Our reference: P-454606-S0K1
Contact: Kathryn Saunders, Principal Planner
Telephone: (02) 4732 8567

**Modification Application – SSD-10101987 – Kemps Creek Data Centre
Response to Submissions (RtS)**

Figure 1: Excerpt from Habit8 plan no. L32

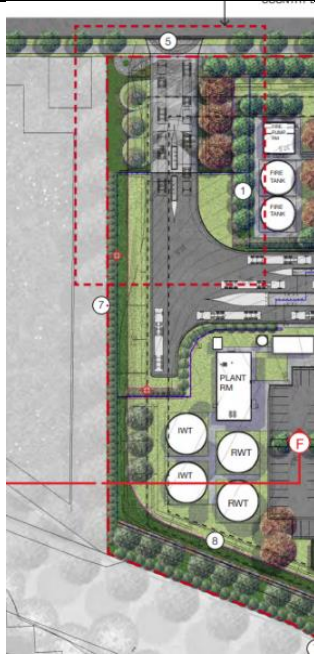
- Conditions of consent are to be included requiring the artworks to be completed and delivered prior to the issue of any Occupation Certificate.
- Landscape plan no. L21 (**Figure 4**) indicates tree planting along the whole length of the Site's western boundary. Plans at Figures 1 and 2 indicate minimal planting which will not screen services tanks and the scale of the building.

Tree planting is formally spaced. Tree planting is to include 'stands' and is to include less formal spacings/alignments, noting the maximum spacing requirements under the MRP DCP are to be observed. Plan no. L32 indicates limited tree planting along this same western elevation. Plans are to correlate and tree planting is to be included.

Figure 3 (above) – Landscape Section through Basin 1 - Excerpt from Habit8 plan no. L12 revision J.

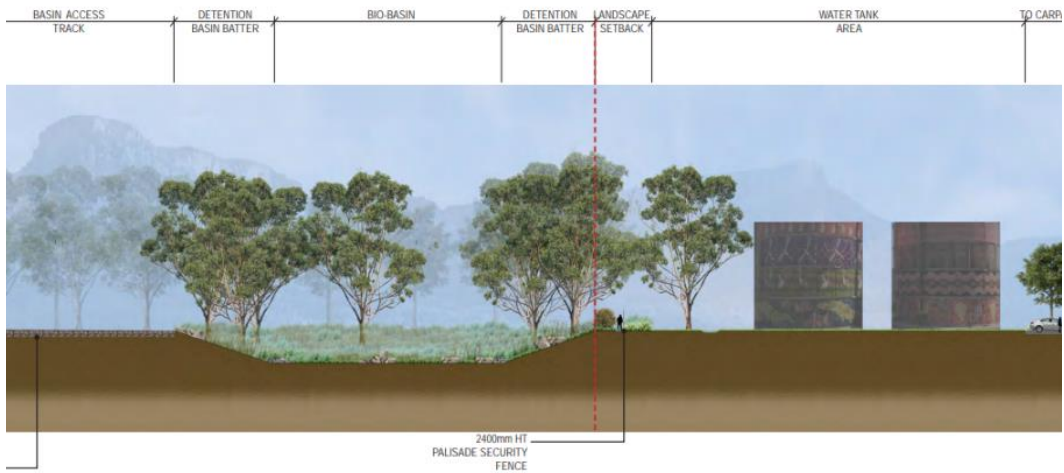
Habit8 Landscape plan - Section F-F, drawing L12, indicates additional service tanks will be provided with images and artworks.

- It is recommended that the Habit8 landscape plan set be updated to reflect the additional artwork commitments identified on the larger service tanks (noted as IWT and RWT) adjacent to the south-western elevation (refer Habit8 landscape plan L12, revision J).

DPE are to review the approved basin plan and planting schedule under SSD-9522, to ensure that the planting indicated on Landscape Section F-F (Habit8 plan no. L12 – Figure 3 below) is approved and will be delivered.
